## **Appendix A**

### **Comments and Responses to Comments**

RE: Comments on Draft AB 3030 Groundwater Management Plan for  
the San Juan Creek Groundwater Basin

TO: Dan Ferons, SJBA  
 FROM: Richard Bell, MWDOC  
 SUBJECT: Technical Comments on the SJBA Draft GW Management and Facilities Plan

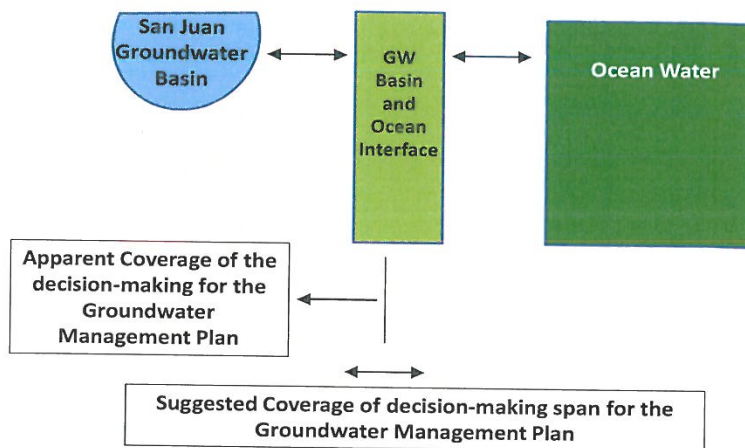
The draft Groundwater Management and Facilities Plan indicates an impact on the basin by the Doheny Desal Project at 1,700 afy. Based on the modeling work, the average impact over the 64-year base period was found to be 1,660 afy. However, as noted above, the base case runs induced seawater intrusion. To control seawater intrusion, basin production would have to be reduced by about 300 to 400 afy to maintain a net positive outflow to the ocean in order to prevent seawater intrusion. Using these numbers would reduce the Doheny Desal Project impact to about 1,300 afy over the 64-year

period. These runs will need to be completed in the next phase of work. The Draft GWM&F Plan should note the yield for both the dry and average periods.
